UNITED STATES PATENT AND TRADEMARK OFFICE

APPLICATION NO.	FILING DATE	FIRST NAMED INVENTOR	ATTORNEY DOCKET NO.	CONFIRMATION NO.
10/767,212	01/28/2004	Frederick J. Dojan	005127.00277	2583

Office Action Summary

DETAILED ACTION

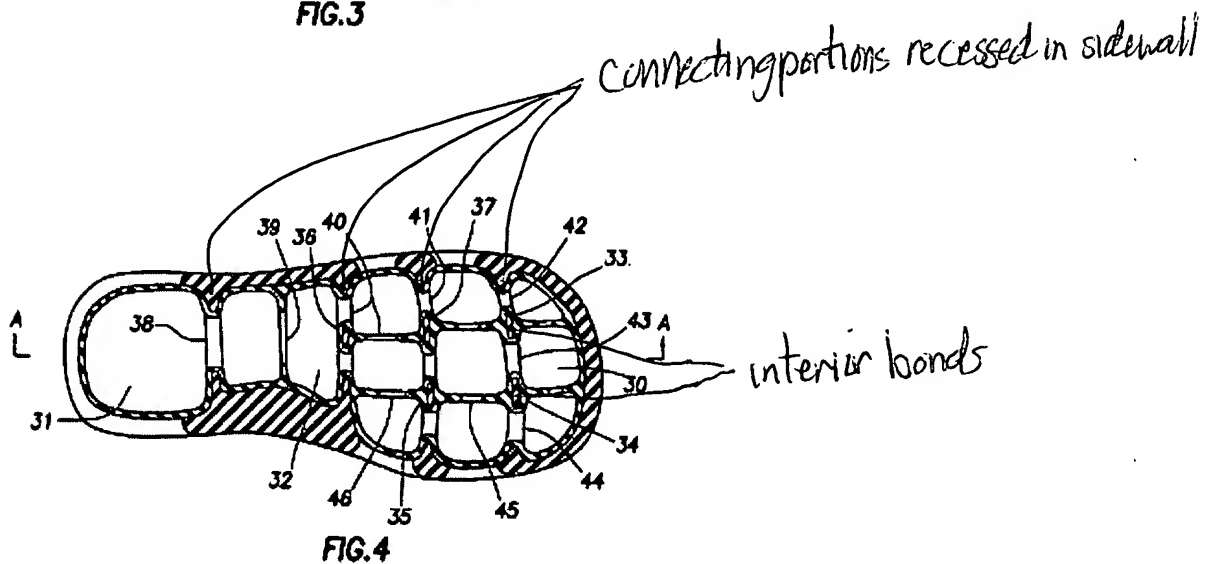
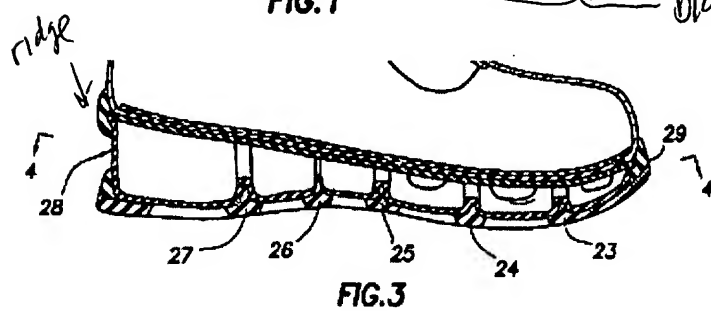
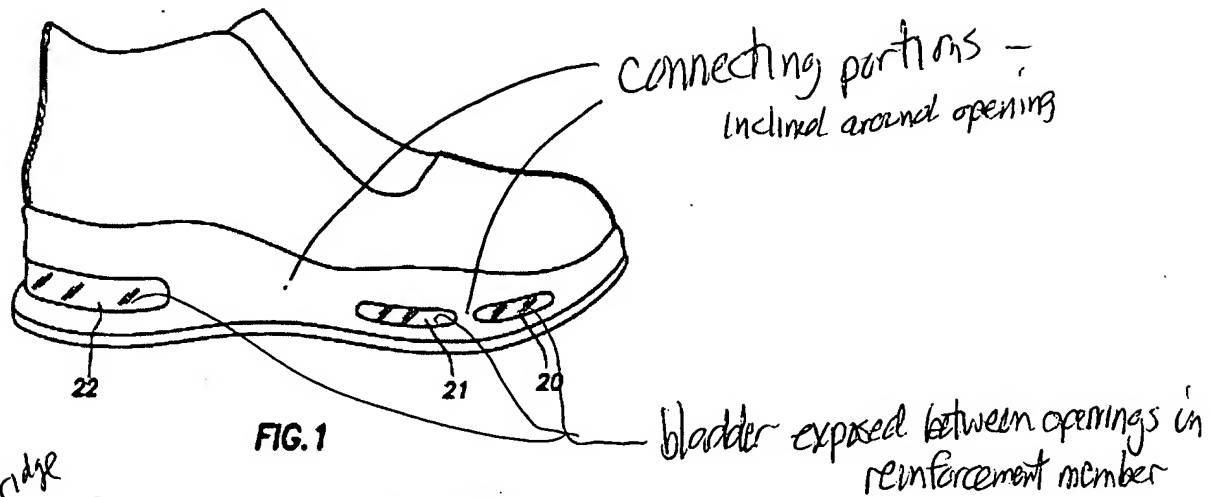
4. Claims 1,9,10,15,26,27 are rejected under 35 U.S.C. 103(a) as being unpatentable over US 6918198 (Chi).

Chi teaches a sole component including a bladder (36) and a reinforcement structure (312) at least partially recessed into the barrier material as claimed except the structure formed of a non-foam and non-rubber material (claim 1), the structure has a greater modulus of elasticity (claims 9 and 26) and the structure having a greater stiffness as claimed (claim 27). Chi is silent with regard to what the material of the reinforcement structure. However, it would have been obvious to one having ordinary skill in the art at the time the invention was made to construct the structure out of non-foam and non-rubber material, since it has been held to be within the general skill of a worker in the art to select a known material on the basis of its suitability for the intended use as a matter of obvious design choice. *In re Leshin*, 125 USPQ 416. Chi is silent with regard to the modulus of elasticity and the stiffness of the reinforcement structure and the barrier material. However, it is conventional and well known in the art for bladder to have a lower modulus of elasticity and stiffness than the structure enclosing the bladders. Bladders have a lower module of elasticity and stiffness inasmuch as bladders in the footwear art provide a cushioning effect for the wearer. Therefore, it would have been obvious to provide the reinforcing structure of Chi with a greater modulus elasticity and stiffness than barrier material of the bladder. Regarding claim 10, it would be obvious to construct the reinforcement structure out of a first and second different material inasmuch as a plurality of different materials can be used to based upon the characteristics desired for the individual.

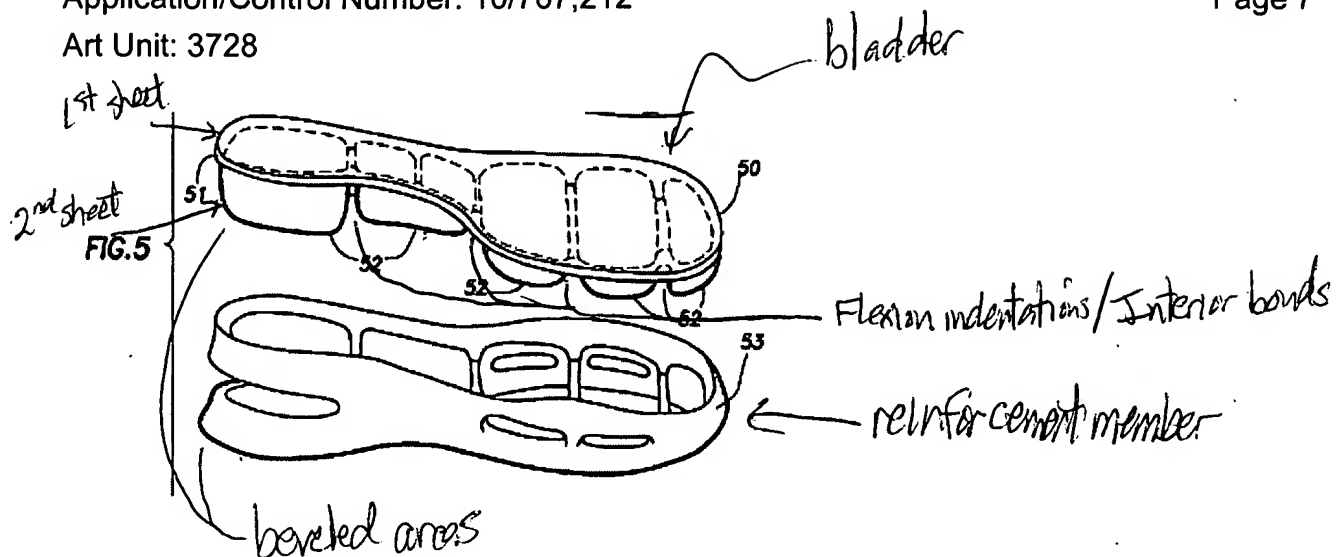
Pavone teaches a sole component as claimed including a bladder and a reinforcing structure at least partially recessed into the barrier material as claimed. See the marked-up figures below.

Pavone teaches a sole component as claimed (as noted above) except for the modulus of elasticity of the materials as claimed (claim 16) and portions of the reinforcing structure being in tension (claim 16 and 25). Pavone is silent with regard to the modulus of elasticity. However, it is conventional and well known in the art for bladder to have a lower modulus of elasticity than the structure enclosing the bladders. Bladders have a lower module of elasticity inasmuch as bladders in the footwear art provide a cushioning effect for the wearer. Therefore, it would have been obvious to provide the reinforcing structure of Pavone with a greater modulus elasticity than barrier material of the bladder.
